Item ID: D212-725-1-901

Item Name: COLLECTIVE BELL CRANK ASSEMBLY

From: Jason Murdoch [jmurdoch@dartaero.com]
Sent: February 12, 2010 7:15 AM
To: 'L Lacelle'; mfauteux@dartaero.com
Cc: 'David Shepherd'; 'Bill Beckett'; 'Susanne Sheldon'; 'Mike Petsche'
Subject: FW: QC issues

B	07.05.11	UPDATE MATERIAL & GRAIN DIRECTION	
A	06.12.08	NEW ISSUE	
DESIGN DC	DRAWN BY RF	DART AEROSPACE LTD HAWKESBURY, ONTARIO, CANADA	
CHECKED DS	APPROVED 	DRAWING NO. D212-725-1	REV. B SHEET 4 OF 44
DATE 07.05.11	TITLE 212S DETAIL PARTS		SCALE 1:2
COPYRIGHT © 2008 BY DART AEROSPACE LTD. THIS DOCUMENT IS PRIVATE AND CONFIDENTIAL AND IS SUPPLIED ON THE EXPRESS CONDITION THAT IT IS NOT TO BE USED FOR ANY PURPOSE OR COPIED OR DISSEMINATED TO ANY OTHER PERSON WITHOUT WRITTEN PERMISSION FROM DART AEROSPACE LTD.

D212-725-1-901 COLLECTIVE BELLCRANK ASS'Y

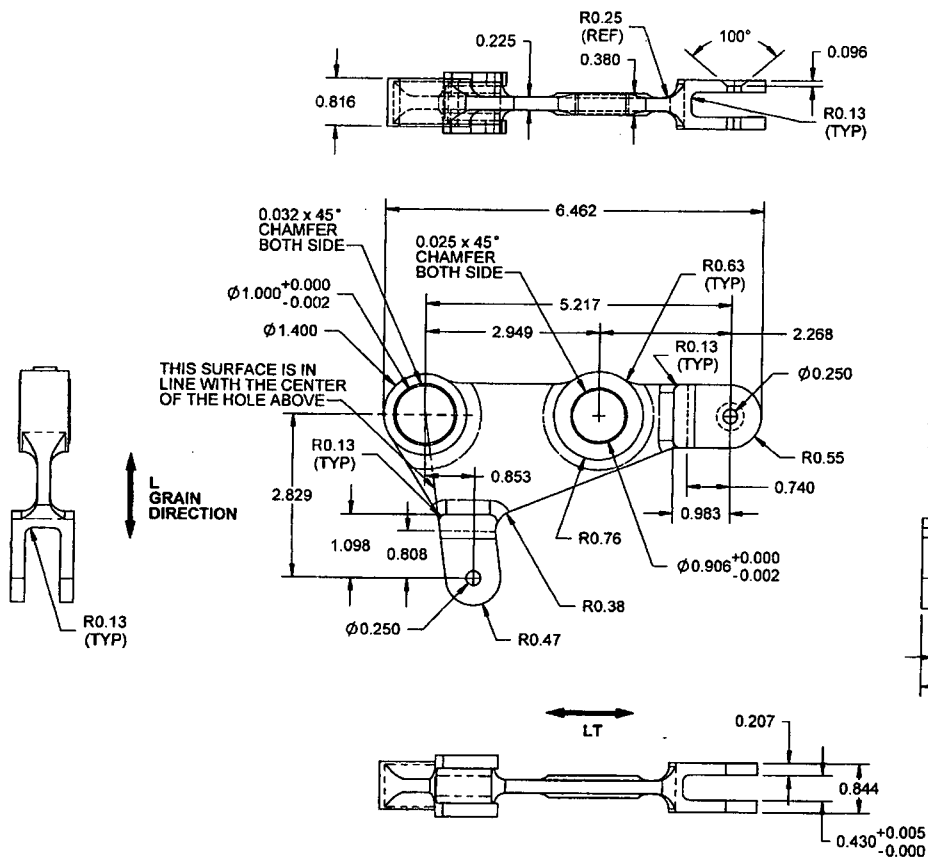
Item 1 - We will update the drawing to reference "paint per QSI 005 and it should be yellow

Item 3 – We will update the drawing with the swaging information

- Where are we at with producing the -901 assembly? WIP right now. What kind of primer finish will these have, yellow / grey as per QSI 005 4.2? See attached. Also, not sure what you are looking for when mentioning on the DART drawing to "PRIME & PAINT PER AIRCRAFT MAINTENANCE MANUAL". It should be referencing QSI005.

- Let me know if you need the production details again i.e. swaging information, tools, etc: This information should be included on the D212-725-1-901 drawing. Linda does have the details, and it is attached to the w/o: the staking info should be initialed off by Mike.P even though there is an e-mail attached with it.

Please go ahead using the instructions that Harvey prepared for installing and staking the bearings.

These should be incorporated into a QSI.

We plan to release the updated drawing next Friday.

We created the w/o to assemble the D212-725-1-901 per the Rev.B drawing (until it goes up to Rev.C to include the Swaging instructions, and Prime per QSI 005 4.2)
